VALUE ENGINEERING CHANGE PROPOSAL  
MISSOURI DEPARTMENT OF TRANSPORTATION

Job No. STP-5414 (609)

**Project:** First Capitol/West Clay STP-5414(609)

**Subject:** Type "S" Curb for Medians and Roadway

**FIRST CAPITOL (ROUTE 94)  
SECTION**

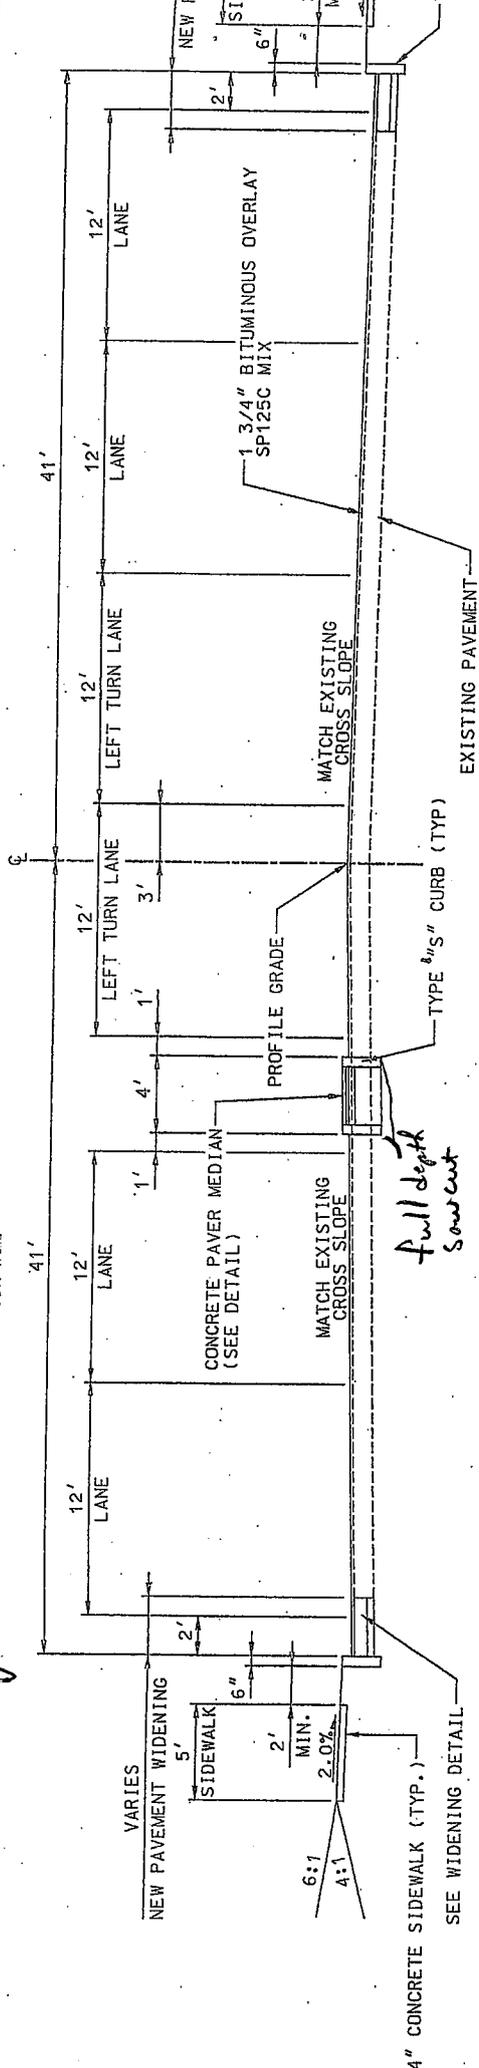
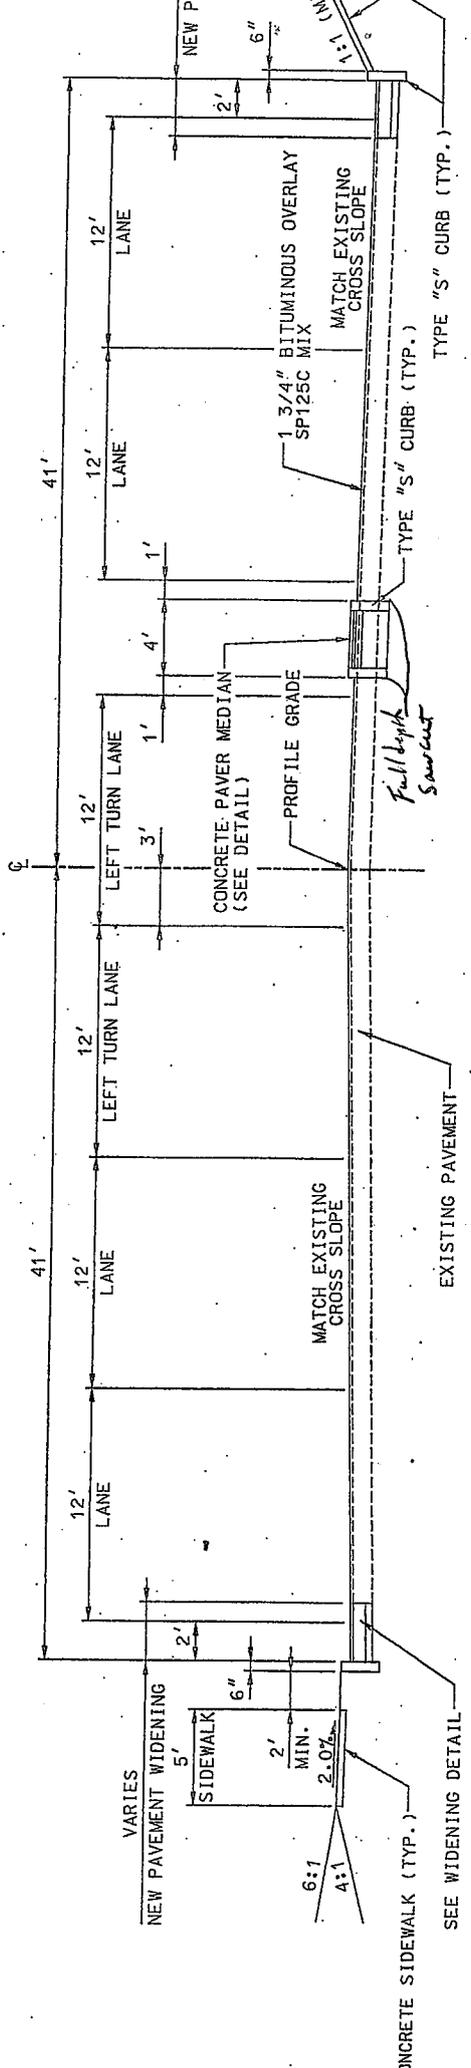
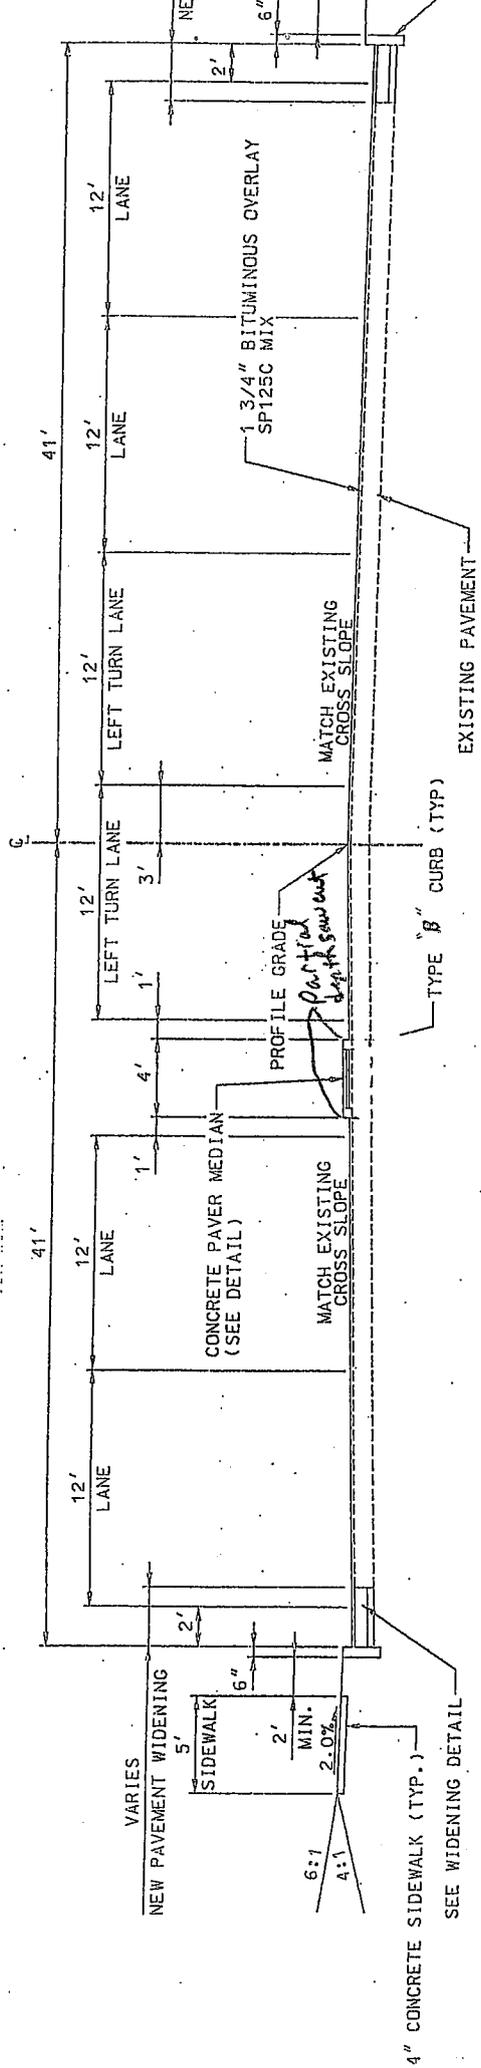
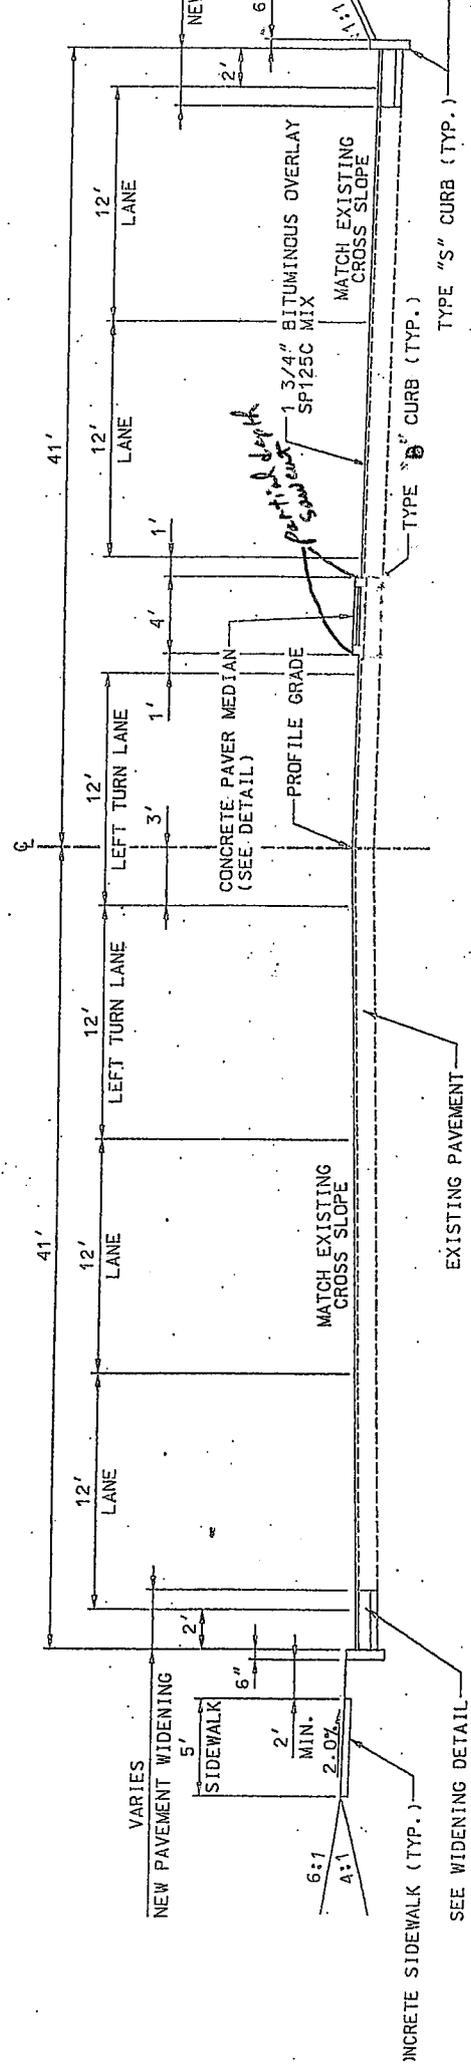
In the area of the new medians the plan called for Type "S" Curb which would cause the pavement to be saw cut full depth at the face of the curb. The pavement in this area is structurally sound and in good condition. Saw cutting this area of roadway could compromise the integrity of the pavement, allow water infiltration and could cause future problems. The use of Type "S" Curb in this area would allow a full depth joint that could allow water to infiltrate in this area.

I believe a better alternative would be Type "B" Barrier Curb as highlighted in the enclosed drawing. The curb could be installed on the existing concrete after the asphalt is partially saw cut to the top of concrete and removed. The asphalt in this area is about 4" thick and this would be saw cut and removed to allow the installation of the Block Pavers as designed. This method of installation would keep the concrete base in tact and keep water from infiltrating into the rock base and sub grade. The curb would be installed as to leave 6" exposed after the final lift of asphalt is installed.

In the area of the base widening the plan also called for Type "S" Curb to be installed at the edge of the new base widening. This would also leave a full depth joint right at the area where water drains down the roadway against the curb. This would leave the possibility of water infiltration into the rock base and sub grade.

I believe, once again, the Type "B" Barrier Curb would allow for a better joint seal and a better finished product. The curb would be installed on the base concrete allowing for 6" of curb exposed after the final lift of asphalt is installed.

**Comments:** UPON REVIEW OF THESE PROPOSED CHANGES, I AGREE WITH THE INTENT AND DESIGN & ENDORSE THIS V.E. PROPOSAL. JP

**Comments:** BASED ON THE INFORMATION PROVIDED, THE PROPOSED CHANGE SHOULD PROVIDE A BETTER PRODUCT IN ADDITION TO A SIGNIFICANT COST SAVINGS.
